**ACI-ASCE Joint Committee 423 – Prestressed Concrete**

**MINUTES**

**a. *Specification for Unbonded Single Strand Tendon Materials and Commentary (423.7-07)*. Neff**

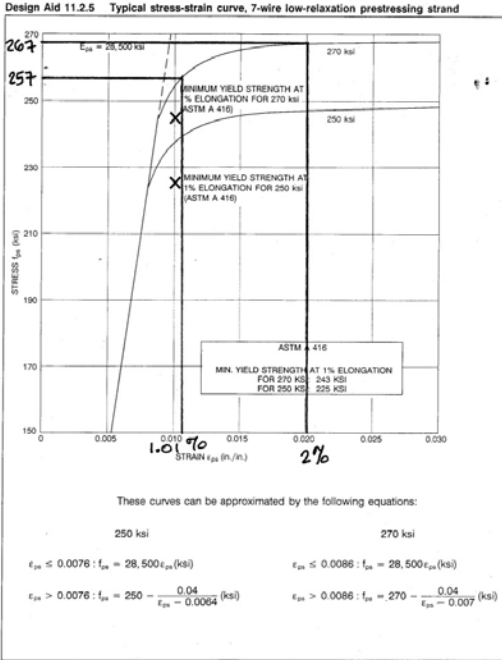
Bondy	4	183	N	<p>Ted's response to my negative vote on this issue in the previous ballot was correct. I have always interpreted this specification to require the 2% elongation <u>at</u> the minimum required strength of <math>0.95f_{pu}</math>. It didn't make sense to me that the strength requirement and the ductility requirement were at different points on the stress/strain curve. The current wording makes it clear, however, that the 2% requirement is at breaking strength, which is presumably greater than <math>0.95f_{pu}</math>. So there are still major problems with this specification.</p> <p>First, since the 2% elongation cannot realistically be achieved at <math>0.95f_{pu}=257\text{ksi}</math>, (where the strain is about 1%), the strength</p>	<p><b>Nonpersuasive</b> – no change</p>

Name	Item No.	Ref #	N or E	Balloter's Comment	Committee Resolution	Rationale
				<p>requirement of <math>0.95f_{pu}</math> becomes meaningless since it <b>must</b> be exceeded to develop the 2% elongation (see the typical stress/strain curve below from the PCI Design Handbook.) To satisfy the ductility requirement in <b>2.7.6</b> the strand must break at about 267ksi (<math>0.99f_{pu}</math>) rather than 257ksi, so the minimum strength specification of <math>0.95f_{pu}</math> in <b>2.7.5</b> becomes irrelevant. If a tendon breaks at 262ksi (<math>0.97f_{pu}</math>) with a strain of 1.5% it satisfies the strength requirement but fails the ductility requirement, therefore it does not satisfy the specification and must be rejected. If we are going to stick to the 2% strain requirement we should logically remove the strength requirement. It doesn't make sense to specify a requirement that is less stringent than another adjacent requirement.</p> <p>More importantly, the 2% elongation requirement is simply unnecessary. It has been shown<sup>1</sup> that it is impossible to achieve an unbonded tendon strain greater than 1% in a real concrete structure by applied loading. Further, with a commonly used value for effective stress <math>f_{pe}</math> of 176ksi, the maximum stress <math>f_{ps}</math> permitted by ACI 318 at nominal strength is <math>176+60=236</math>ksi (ACI 318-11 Section <b>18.7.2(b)</b>). At this maximum stress of 236ksi the (elastic) strain is only <math>236/28500=0.83\%</math>. Why do we need a breaking strain of 2% in a testing machine when the maximum strain required by ACI 318 in a real structure, <b>under any circumstances</b>, is less than half that value? Surely, with all the other factors of safety (<math>\phi</math> and load factors) built into the ACI Code we don't need that much of a spread between testing machine capabilities and actual demands in real structures.</p> <p>Footnote 2 recommends and justifies a fully appropriate, realistic value for this strain of 0.9% and I encourage the adoption of this, or a similar value, in this specification. This value is achievable, consistent with the required strength of <math>0.95f_{pu}</math>, and exceeds all physical demands which can be imposed on an unbonded tendon in a real structure. I will withdraw my negative vote if the strain requirement in <b>2.7.6</b> is reduced to 0.9%.</p>

Item 4, Ref 183: Bondy negative on anchorage testing acceptance developing strain of 2% and stress of 257ksi. To develop 2% strain, it will go up toward 270 ksi to develop that strain level, rendering 257 ksi requirement useless. We are requiring strain testing to be almost 2.5 times higher than will ever be required to develop the maximum strength required by the building code. Strand is delicate at that point of upper stress-strain curve. There is a paper that shows 0.9% is an appropriate strain, yielding almost 257ksi stress. Bondy fearful committee requiring 2% may be grossly conservative for no valid reason. Neff disagrees, citing importance of ductility and imported steels with varying stress-strain properties. Gleich moved to vote Bondy non-persuasive; Russell seconded. Approved by unanimous voice vote; 1 negative.
